A303 Amesbury to Berwick Down

**8.46 – Response to English Heritage objection to PRow to
Visitor Centre**

Response to English Heritage objection to PRow to Visitor Centre

Regulation Number:	Regulation 5(2)(q)
Planning Inspectorate Scheme Reference	TR010025
Application Document Reference	8.46
Author:	A303 Amesbury to Berwick Down Project Team, Highways England

A360 TO STONEHENGE
VISITOR CENTER
NMU FACILITIES ALONG A344
OPTION A

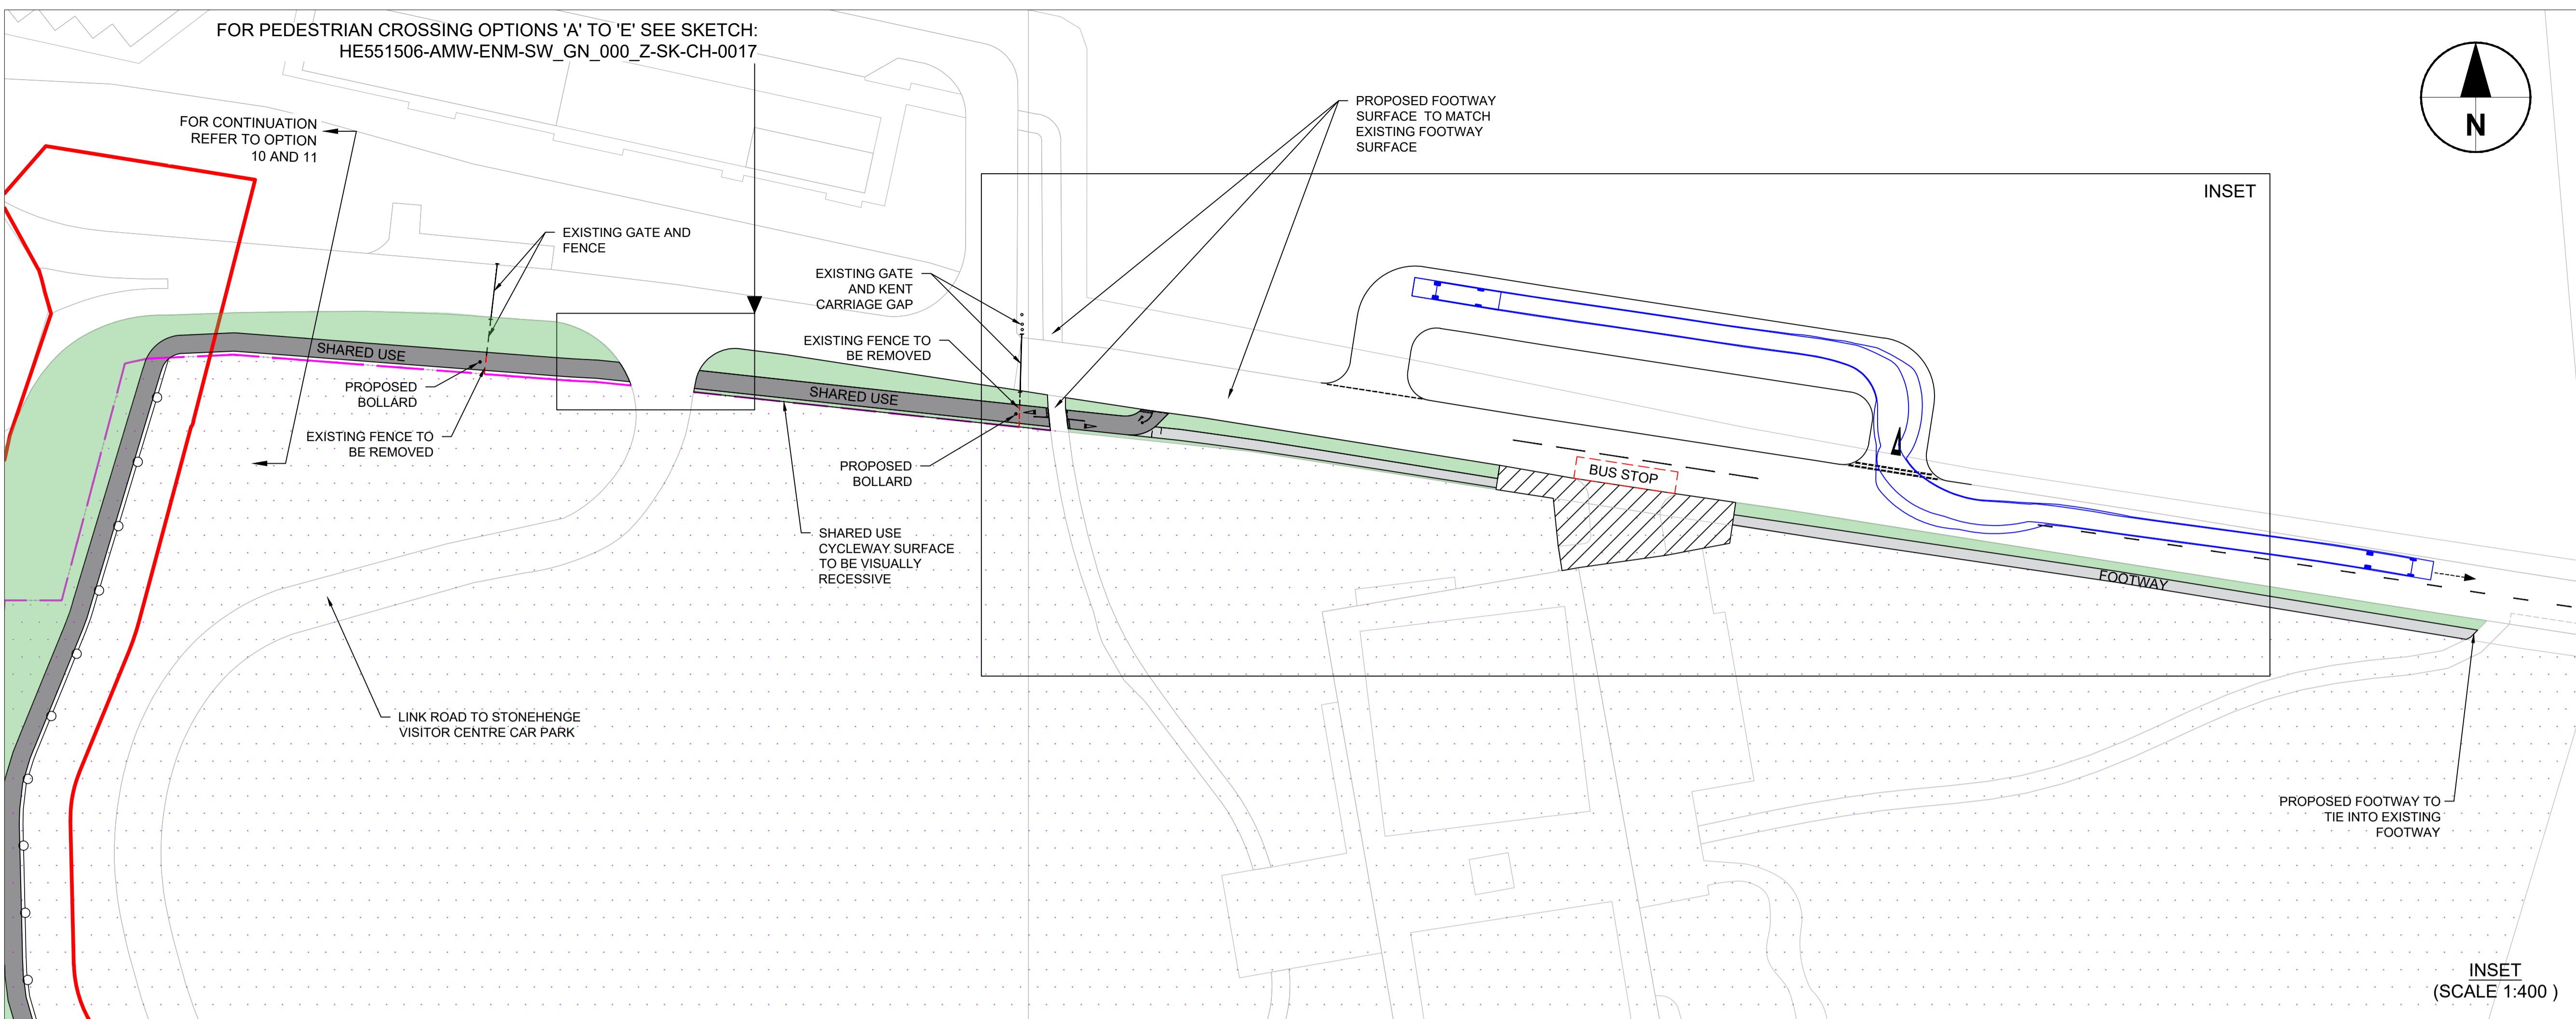
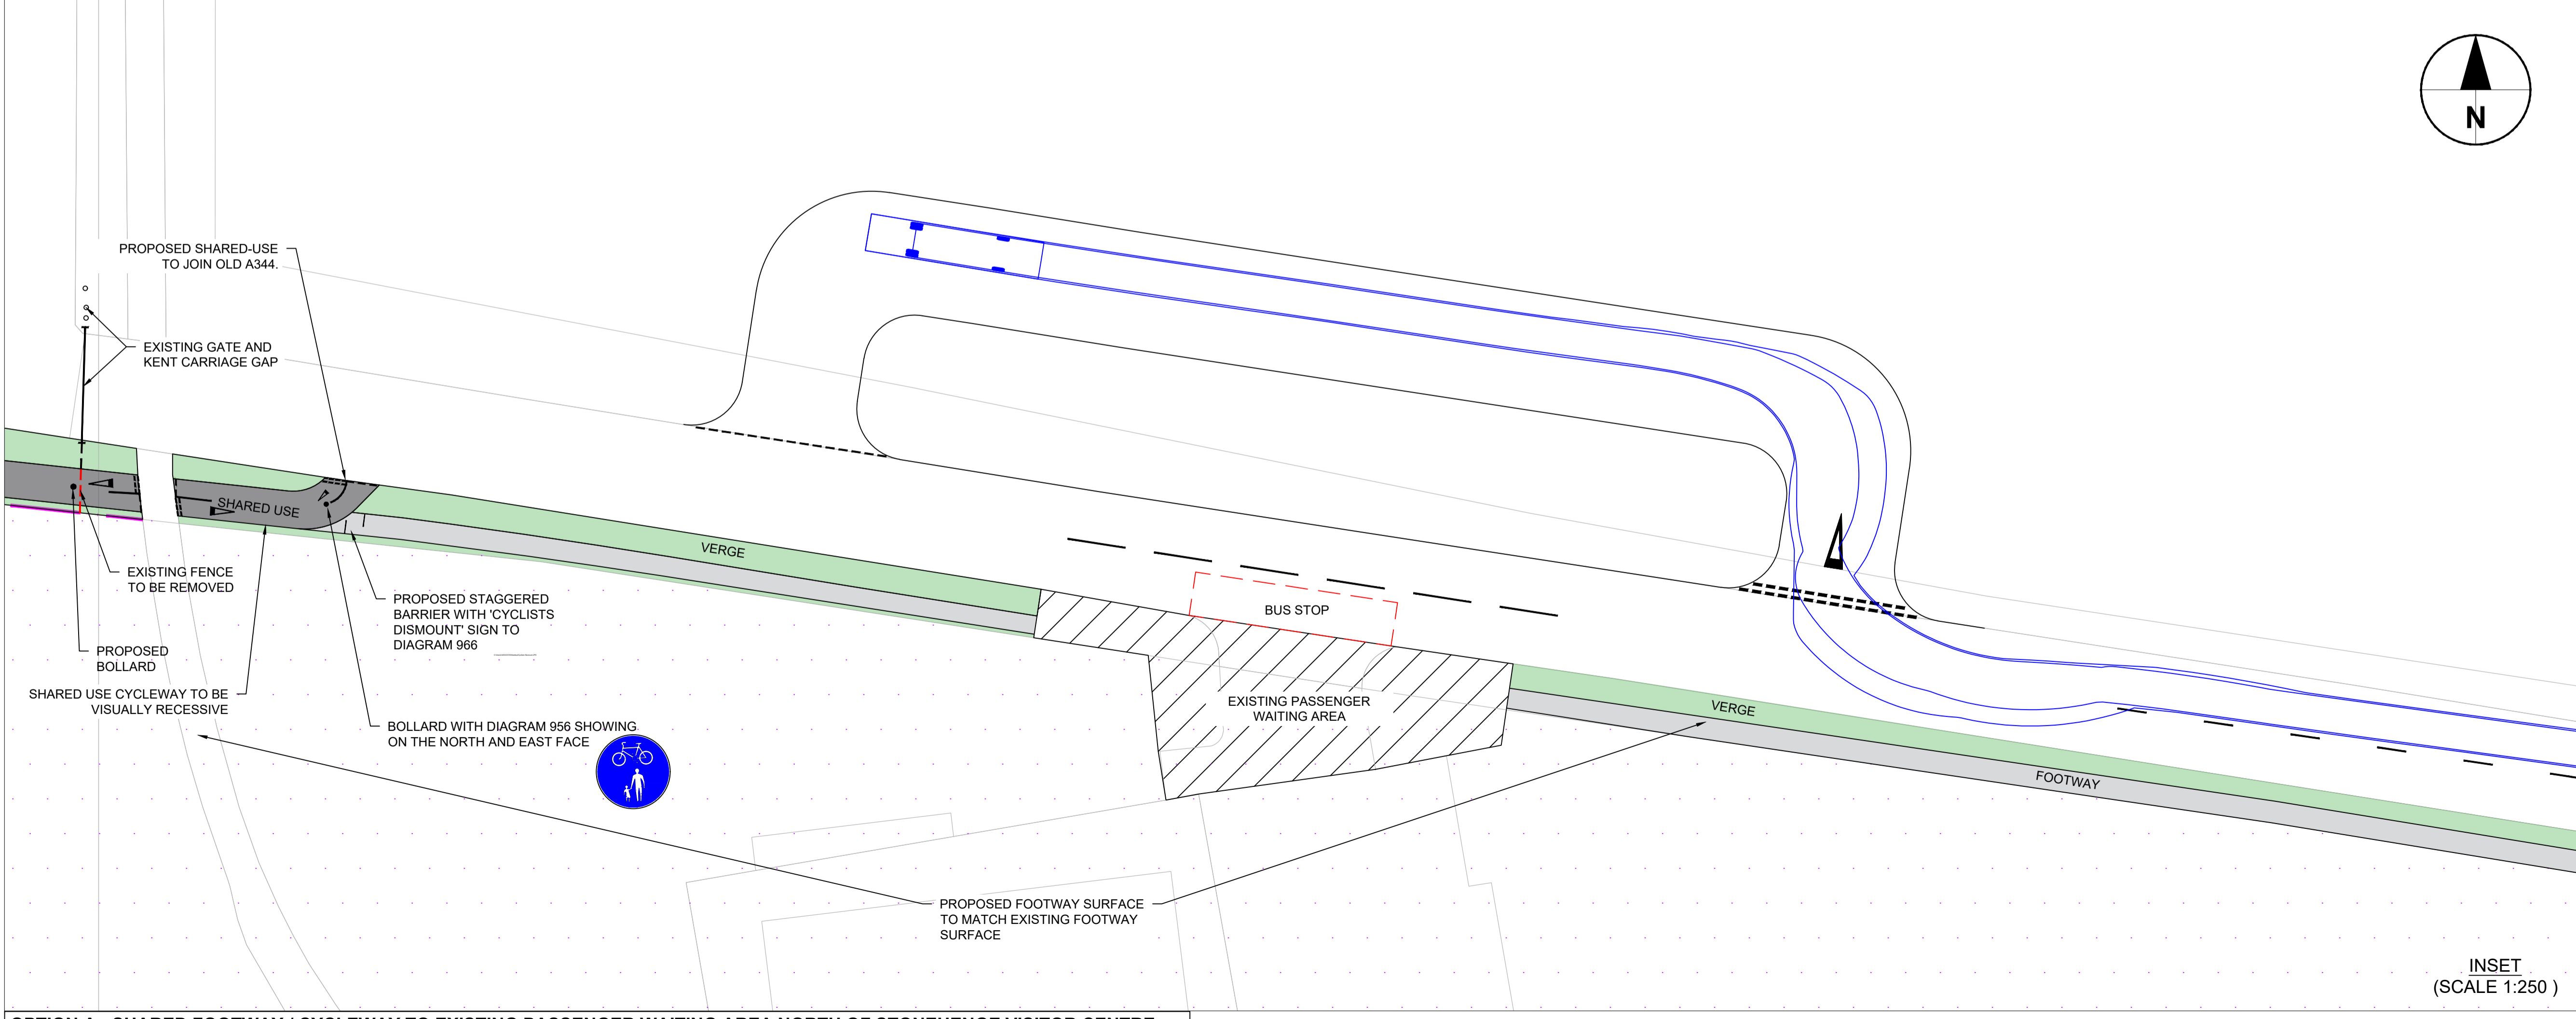
- 6.1.1 Option A proposes that the shared-use cycleway link alignment would be terminated 50 metres west of the passengers' waiting area (on the periphery of the Visitor Centre). The footway element would extend in an easterly direction to meet the existing footway east of the passengers' waiting area. Additional land (an area of 1,175m²) outside the Order Limits would be required. Option A is shown on drawing HE551506-AMW-ENM-SW_GN_000_Z-SK-CH-0309 in Appendix 3 to this report.

A360 TO STONEHENGE
VISITOR CENTRE
NMU FACILITIES ALONG A344
OPTION C

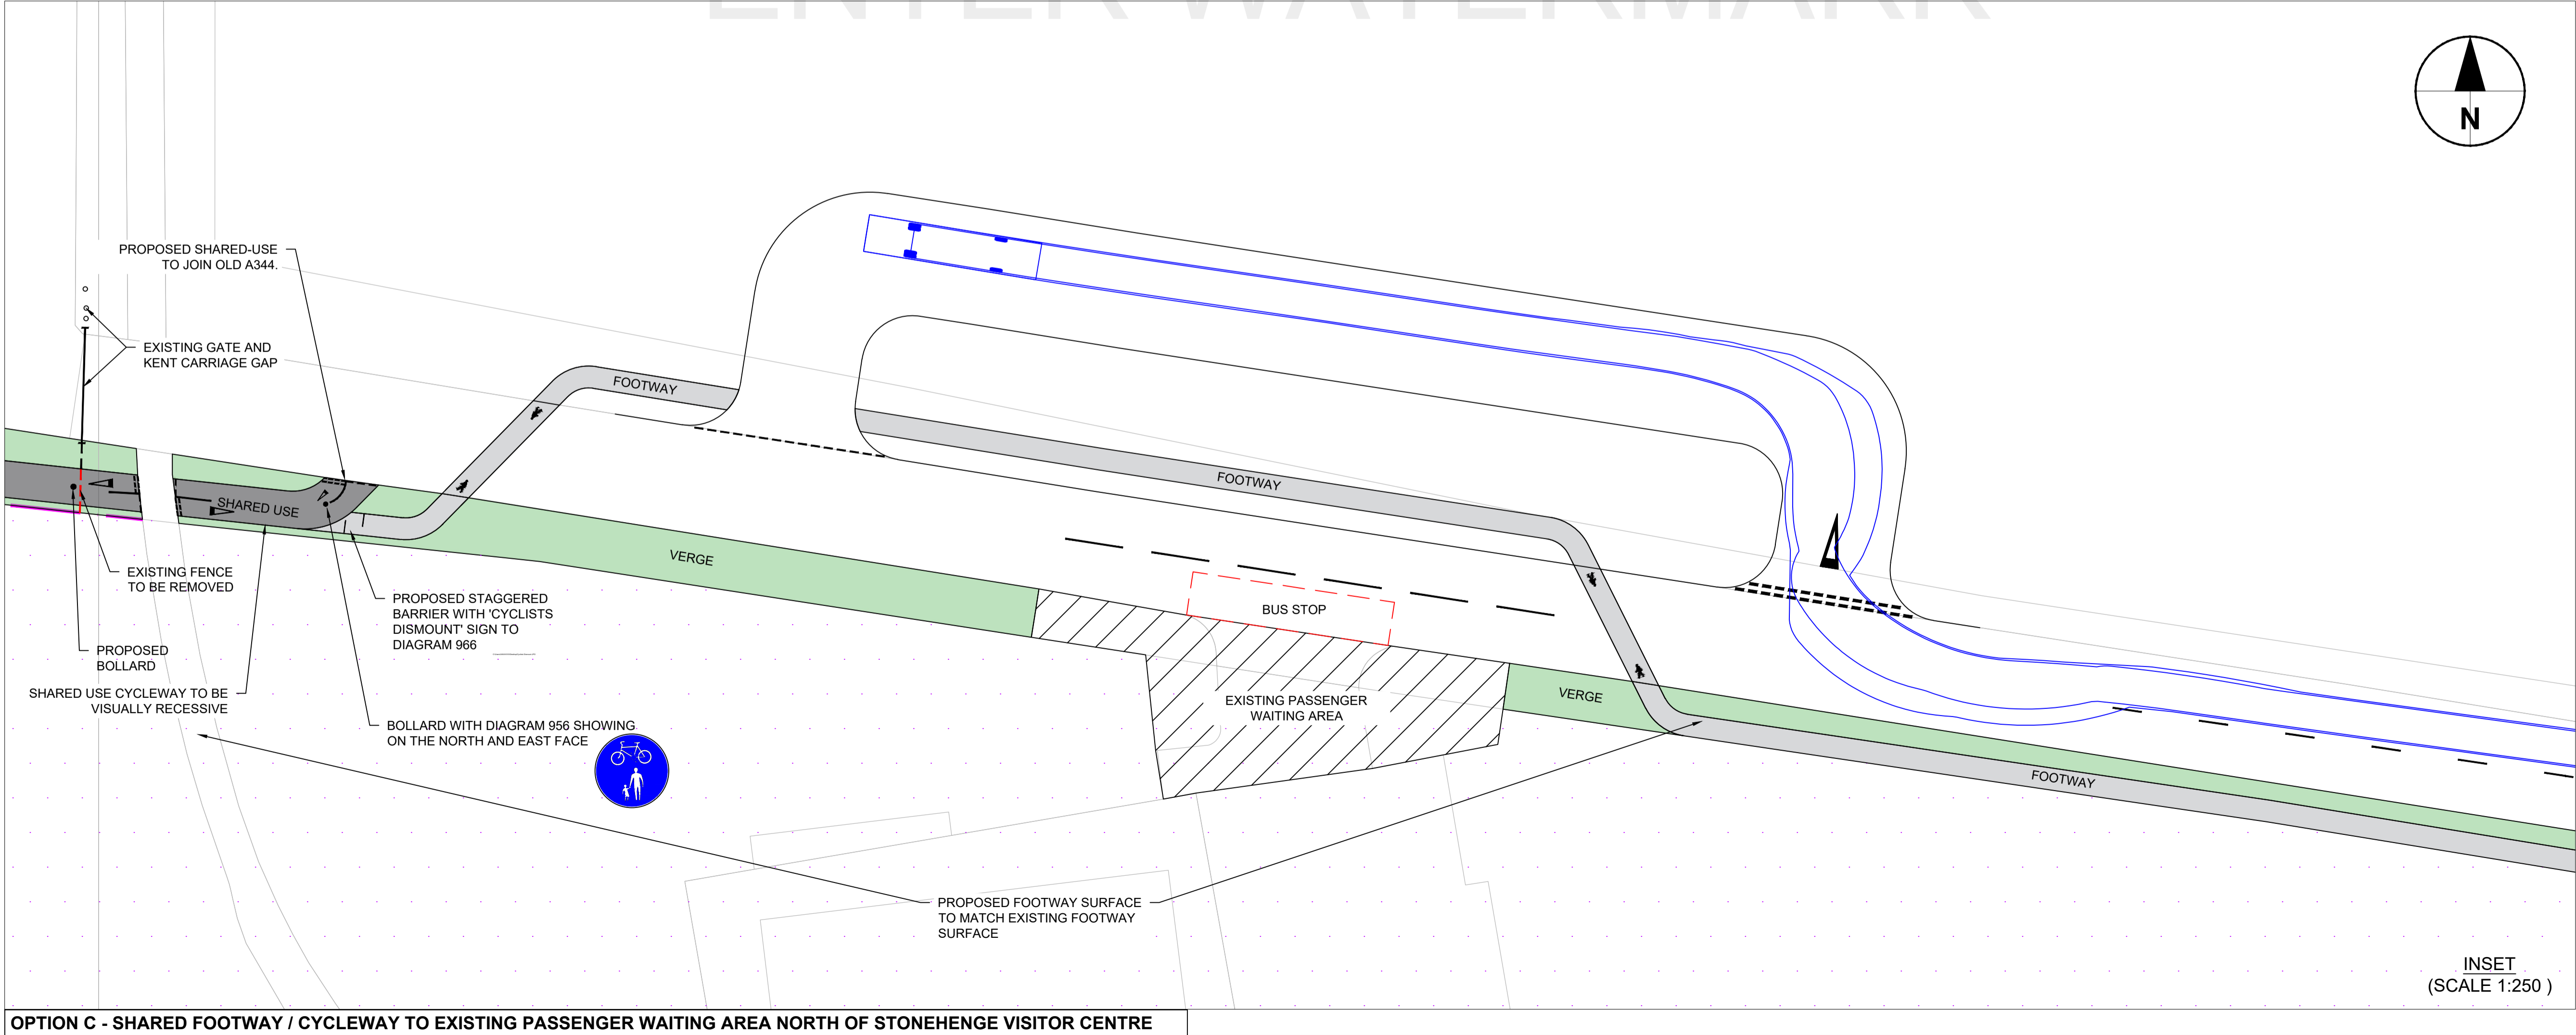
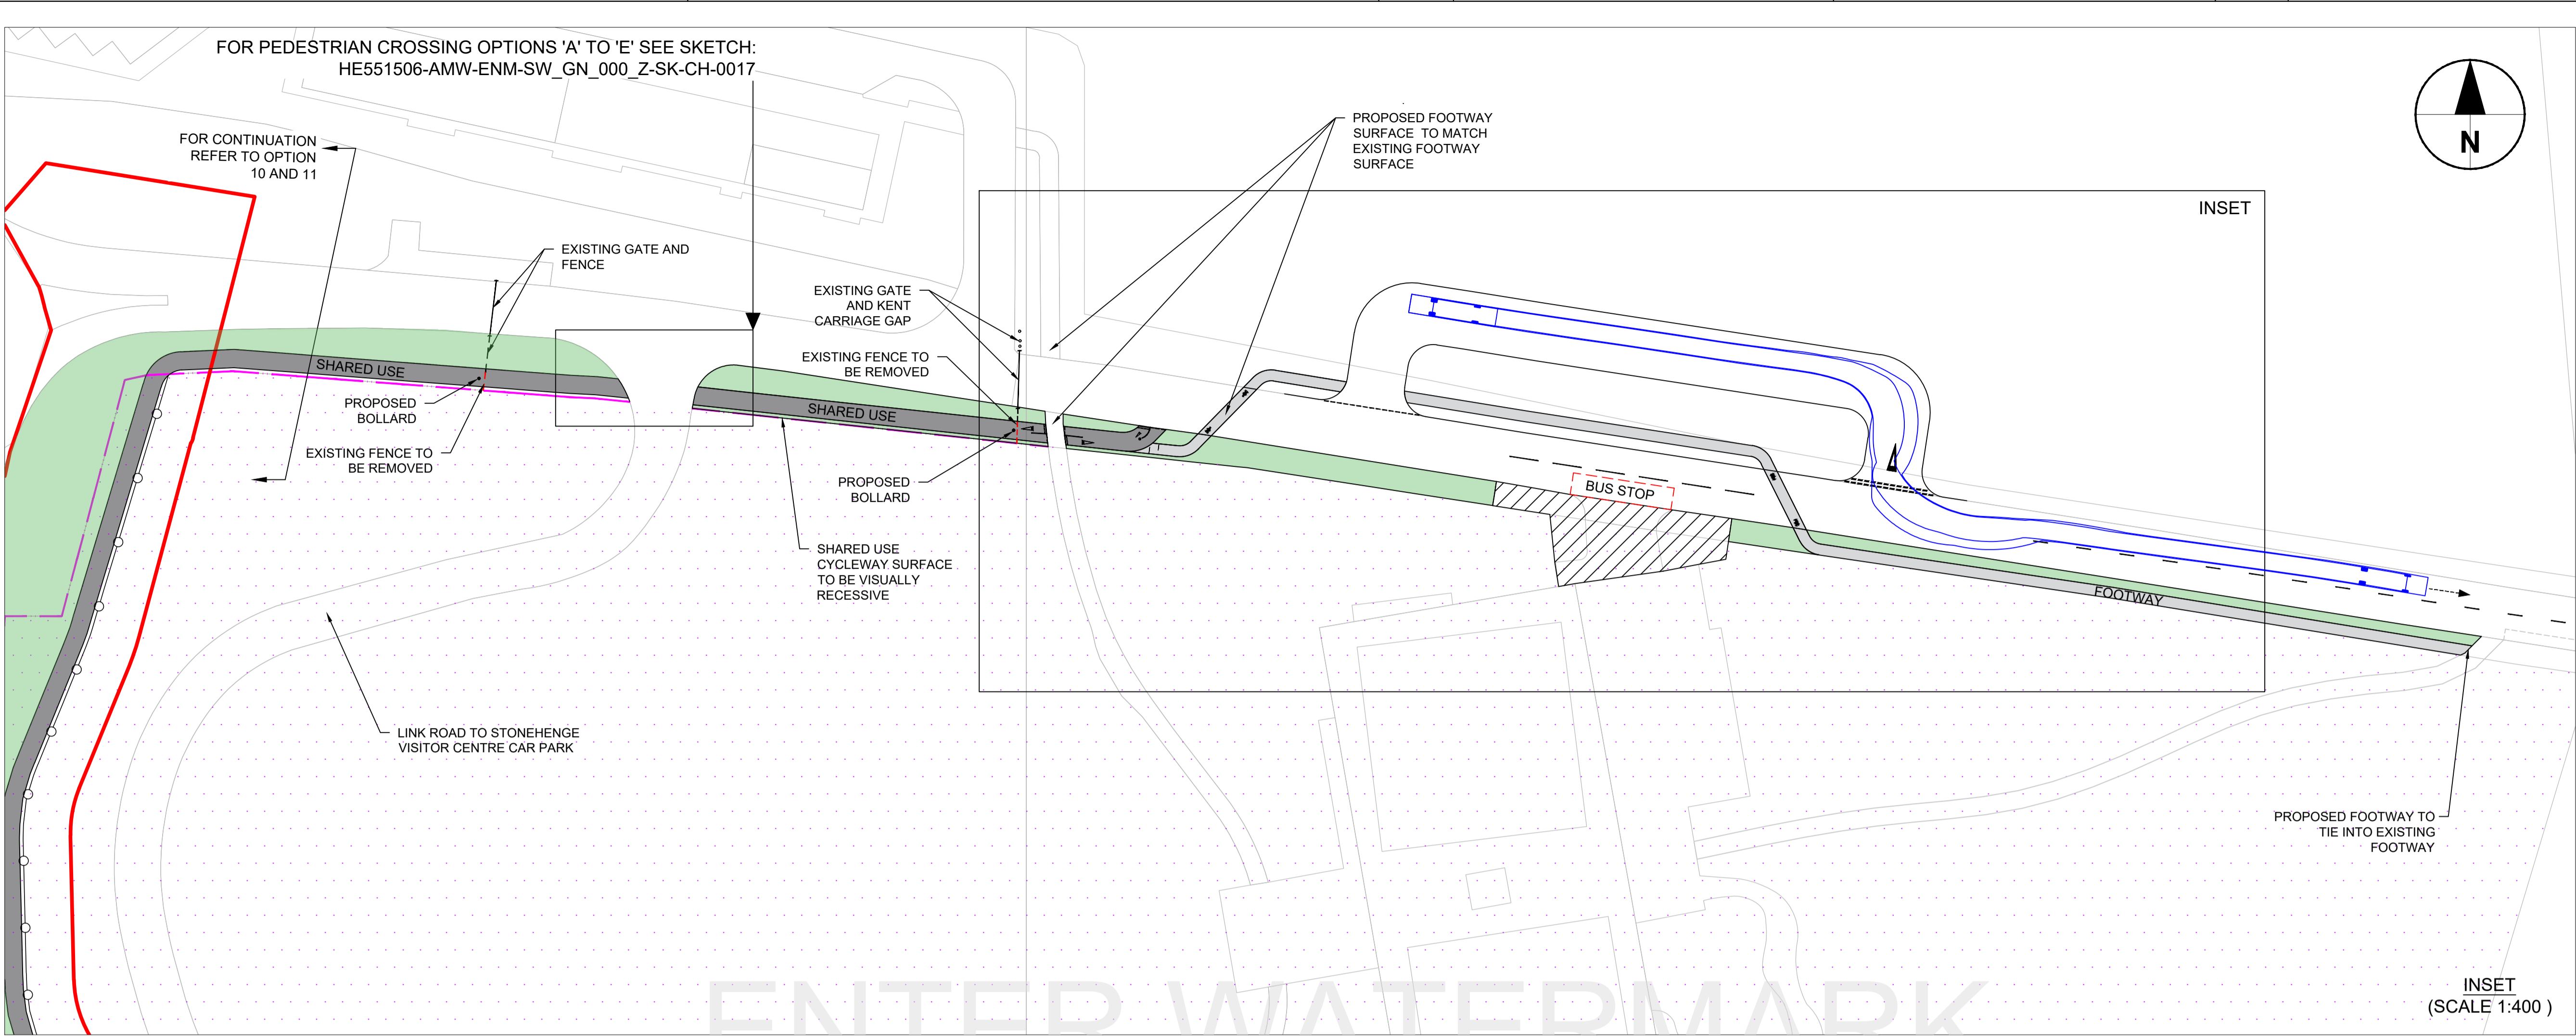
- 6.3.1 Option C proposes that the shared-use cycleway link alignment would be terminated 50 metres west of the passengers' waiting area, with a new footway to be developed on the verge north of the old A344 to avoid the shuttle bus waiting area. Additional land (an area of 1,224m²) outside the Order Limits would be required. Option C is shown on drawing HE551506-AMW-ENM-SW_GN_000_Z-SK-CH-0307 in Appendix 3 to this report.
